HISTORIC AND DESIGN REVIEW COMMISSION

Agenda Item No: 13

HDRC CASE NO: 2017-041
ADDRESS: 302 MISSION ST
LEGAL DESCRIPTION: NCB 944 BLK 1 LOT 28 & N 25 FT OF 29
ZONING: RM-4,H,HL
CITY COUNCIL DIST.: 1
DISTRICT: King William Historic District
LANDMARK: House
APPLICANT: Daniel Canales
OWNER: Terisita Alvarez
TYPE OF WORK: Installation of front porch railings
REQUEST:

The applicant is requesting a Certificate of Appropriateness for approval to install front porch and porch step railings at 302 Mission.

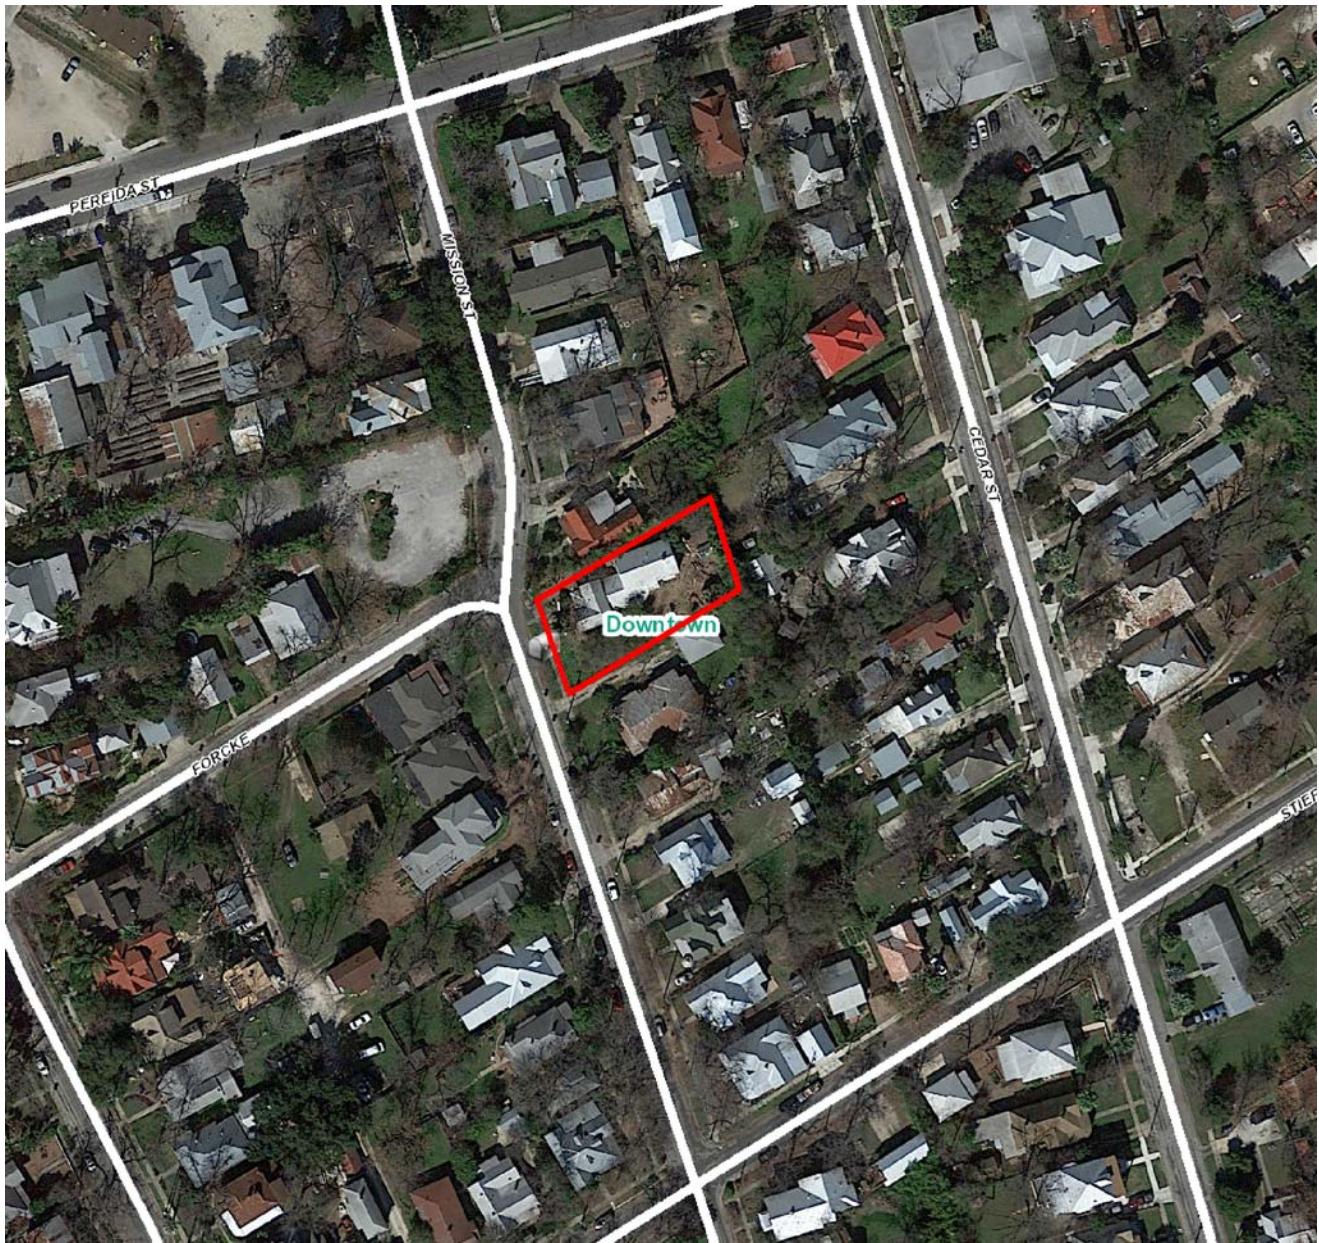
- a. The structure at 301 Mission Street was constructed circa 1900 and features traditional Folk Victorian elements as well as a large rear addition. The applicant has proposed to retain the previously installed front porch railings that were not approved by the Historic and Design Review Commission.
- b. According to the Guidelines for Exterior Maintenance and Alterations 7.B., porch elements should be designed to be simple so as to not distract from the historic character of the building. New elements should not be added that create a false sense of history. The King William Historic District features Folk Victorian structures that both do and do not feature front porch railings. Staff finds the installation of front porch railings appropriate; however,

these railings should feature an architectural profile and dimensions that are appropriate. Staff finds that the proposed porch railing should feature a thinner bottom rail, balusters that are spaced closer together that feature a round or spindled profile and a thinner hand rail. Staff also recommends that the applicant paint the front porch railing a color that is subordinate to the color of the house, such as white.

- i. That the applicant modify the railings to include a thinner bottom rail, balusters that are spaced closer together that feature a round or spindled profile and a thinner hand rail.
- ii. That the applicant paint the front porch railing a color that is subordinate to the color of the house, such as white.
